MEMO

Subject: Review of Water Right Application G-19143

Groundwater Application Review Summary Form

PUBLIC INTEREST REVIEW FOR GROUNDWATER APPLICATIONS

Theis Interference Analysis

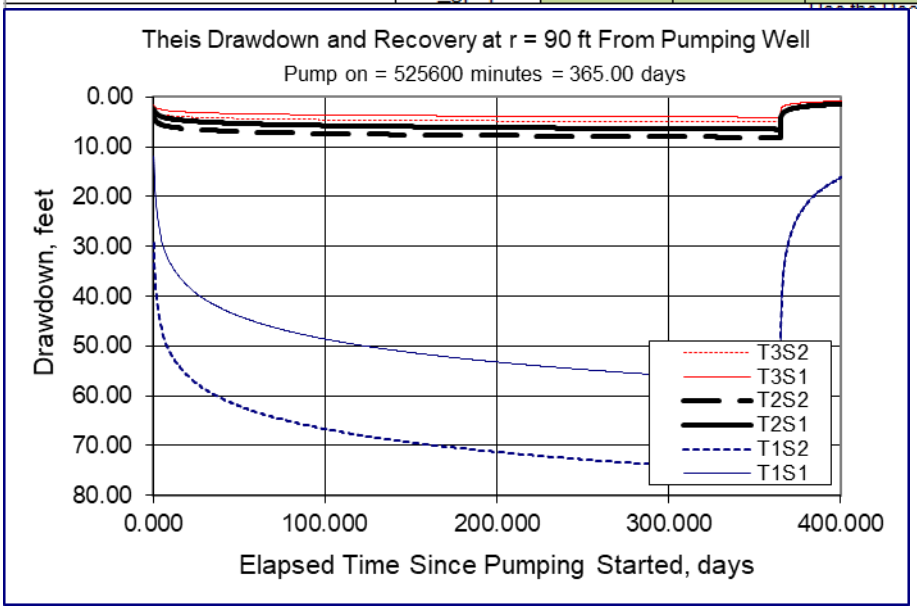
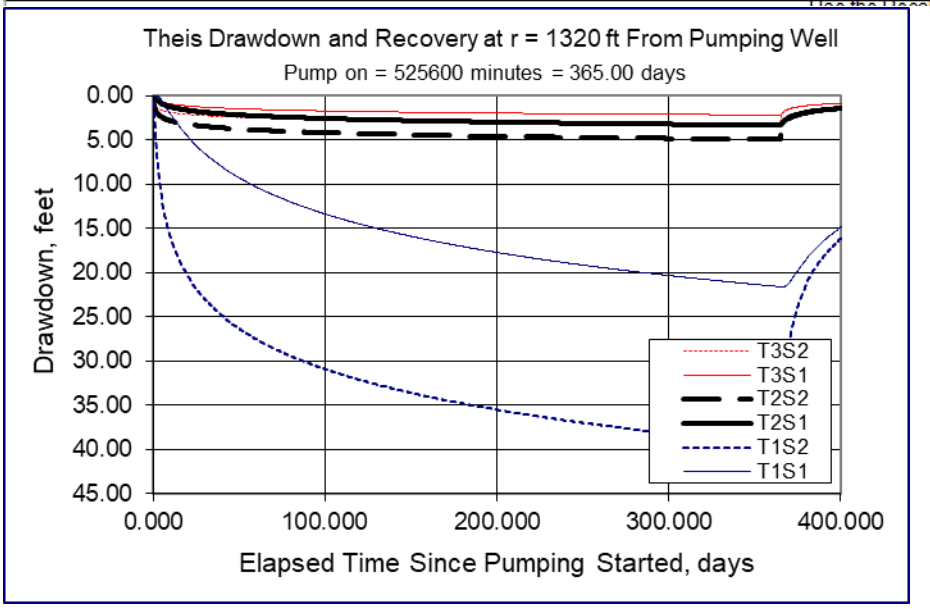
B3. **Groundwater availability remarks:** The proposed POAs are located in the Central Willamette Valley and will produce from approximately 140-150 feet of sand and gravel (the Willamette Aquifer described by Gannett and Caldwell, 1998), which is overlain by about 60 feet of silt (the Willamette Silt Unit) and overlies fine-grained distal alluvial fan and low gradient stream deposits locally separated by thin layers of sand and fine gravel (Willamette Confining Unit). The majority of wells in the immediate vicinity draw water from the Willamette Aquifer. The requested rate (0.155 cfs) is well within the range of reported yields for water wells in this area (see attached well statistics) and is unlikely to injure the closest neighboring wells (see attached Theis analysis).

Note: Exact locations of nearby wells are unknown so these analyses model from the closest possible neighboring well location, which was the closest distance from the proposed POAs to a neighboring tax lot, 90 feet.

Stream Depletion Model Parameters and Output

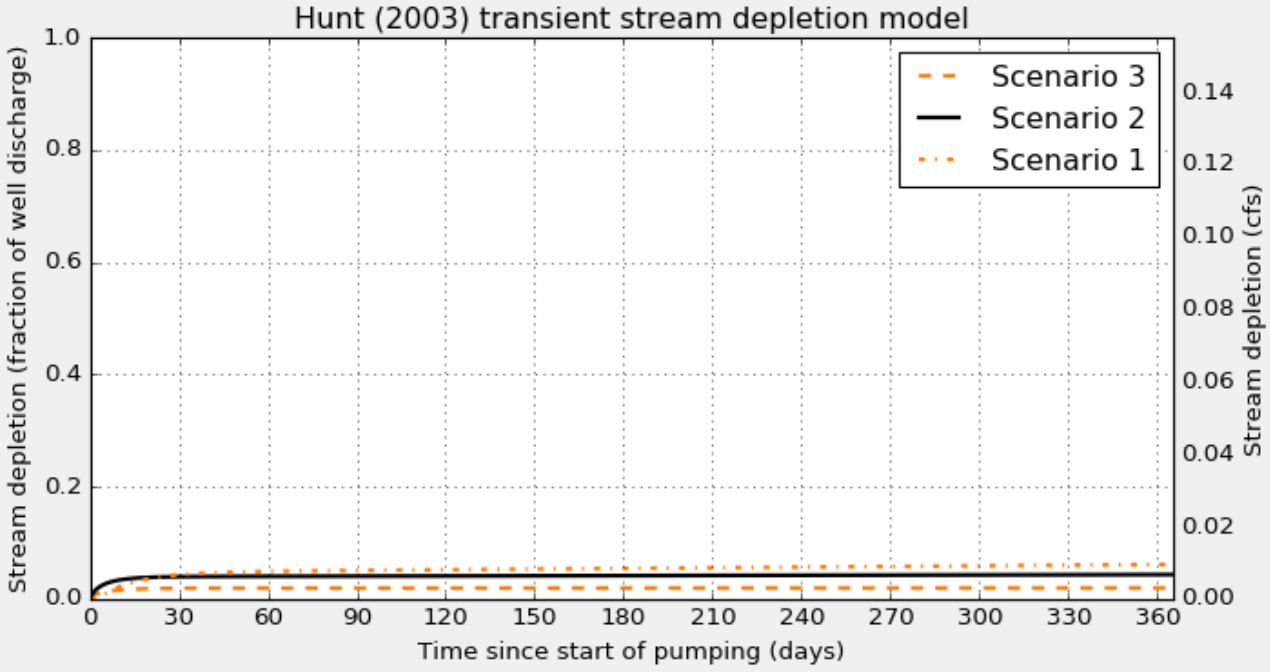
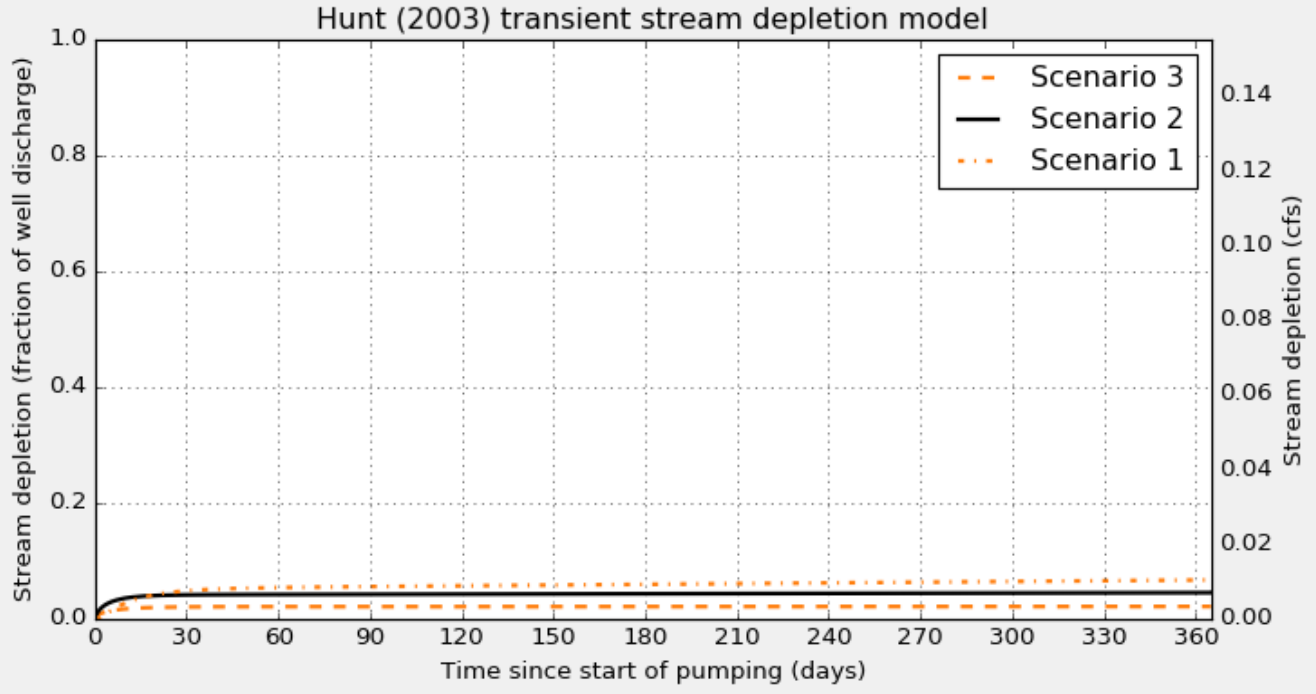
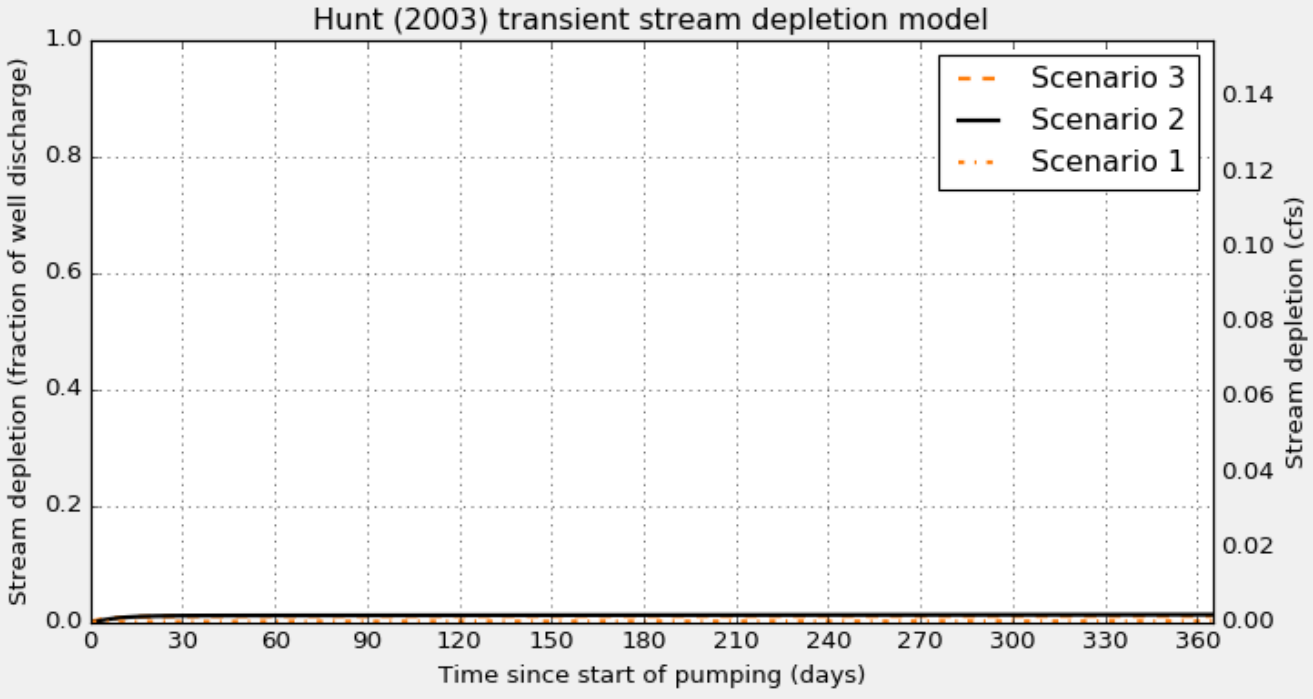
Comments: **The proposed POAs are hydraulically connected to and within ¼ mile of SW 1 (Fruitland Creek). Per OAR 690-009-0040(4)(a), the Potential for Substantial Interference (PSI) is assumed.**

Interference with nearby surface water due to the proposed use was estimated using the Hunt (2003) transient stream depletion model. Hydraulic parameters used for the analysis were derived from regional data and studies (Pumping Test Reports; Conlon, 2005; Iverson, 2002; Woodward et al., 1998) or are within a typical range of values for the given parameter within the hydrogeologic regime (Domenico and Mifflin, 1965; Freeze and Cherry, 1979). Results indicate that interference with surface water sources due to the proposed use is unlikely to exceed 25 percent of the rate of appropriation within the first 30 days of continuous pumping.

C6. **SW / GW Remarks and Conditions:** **To avoid the assumption of PSI per OAR 690-009-0040(a), applicant would need to select well locations more than ¼ mile from the nearest surface water source.**
